UNITED STATES PATENT AND TRADEMARK OFFICE

APPLICATION NO.	FILING DATE	FIRST NAMED INVENTOR	ATTORNEY DOCKET NO.	CONFIRMATION NO.
09/997,494	11/19/2001	Alex P. Weaver	WEAVER.PT1	5181

Office Action Summary

DETAILED ACTION

FIG. 5

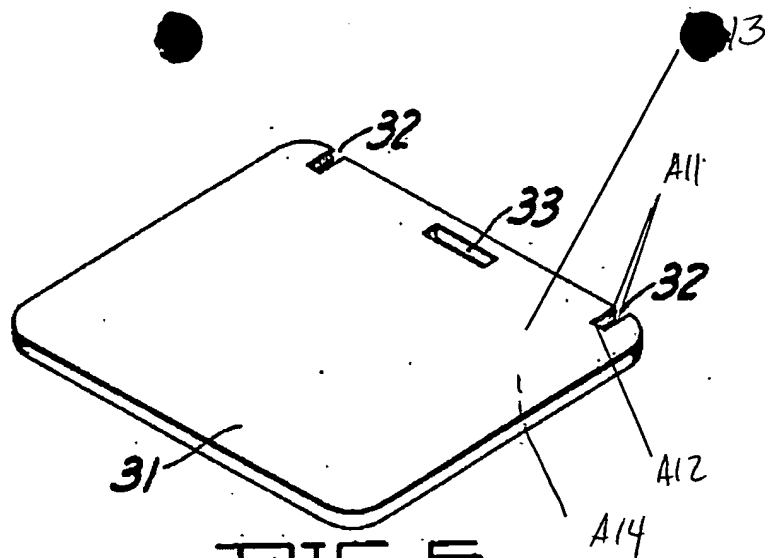
Regarding claim 1, Scarlett discloses in Figures 5 and 8 a double locking mortise joint comprising a first member **A1** and a second member **31**.

The first member **A1** has a first mortise **18**, a first contact surface **A7**, and a second contact surface **A8**. The first mortise **18** is generally perpendicularly with respect to an axis **A3** of the first member **A1**. The first mortise **18** has a gusset top **14**, a head bottom **A5** and a first mortise end **A6**. The gusset top **14** extends generally perpendicularly outward with respect to the axis **A3**. The head bottom **A5** is opposite to and generally parallel to the gusset top **14**. The first mortise end **A6** is generally parallel to the axis **A3** and connects the gusset top **14** and the head bottom **A5**. The second contact surface **A8** is next to the first mortise end **A6**.

FIG. 8

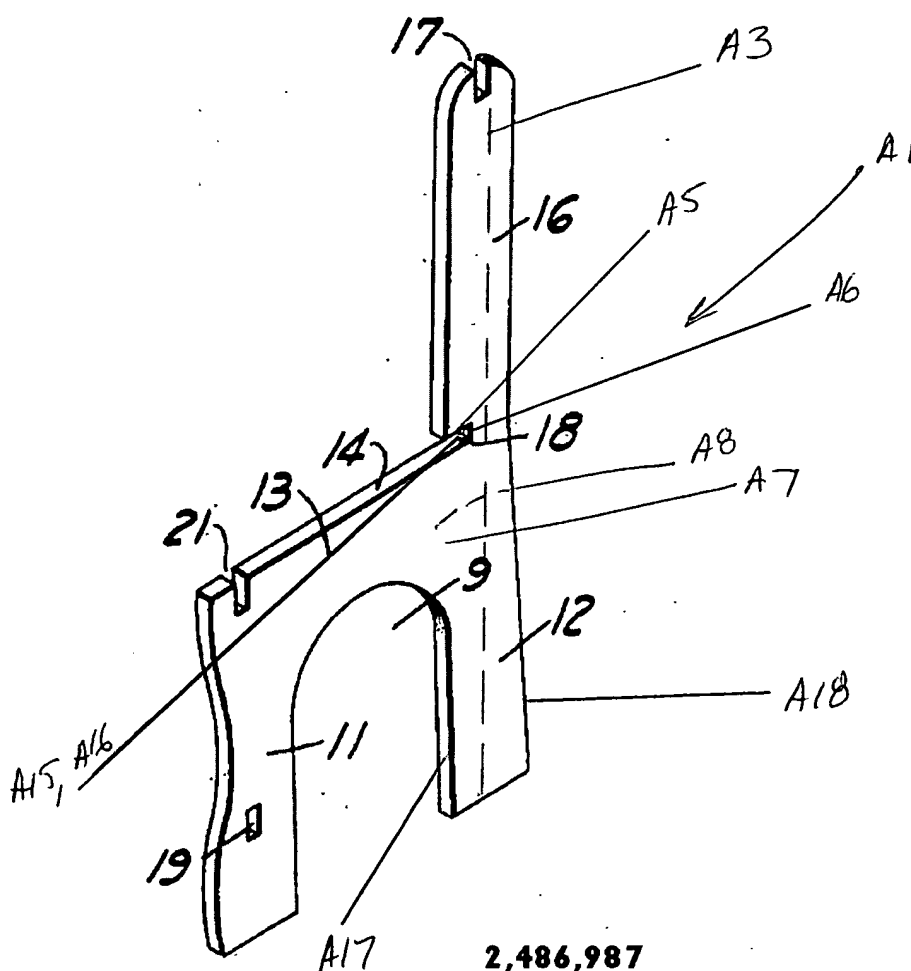
The second member **31** has a second mortise **32**, a top surface **A13**, and a bottom surface **A14**. The second mortise **32** has two opposing sides **A11** being generally parallel to each other. The second mortise end **A12** connects the sides **A11**. The top surface **A13** and the bottom surface **A14** are next to the second mortise end **A12**.

Regarding claim 3, the first mortise **18** further comprises a first mortise corner **A15** and a second mortise corner **A16**. The first mortise corner **A15** is located between the first mortise end **A6** and the head bottom **A5**. The second mortise corner **A16** is located between the first mortise end **A6** and the gusset top **14**. The first mortise corner **A15** or the second mortise corner **A16** is square-edged.
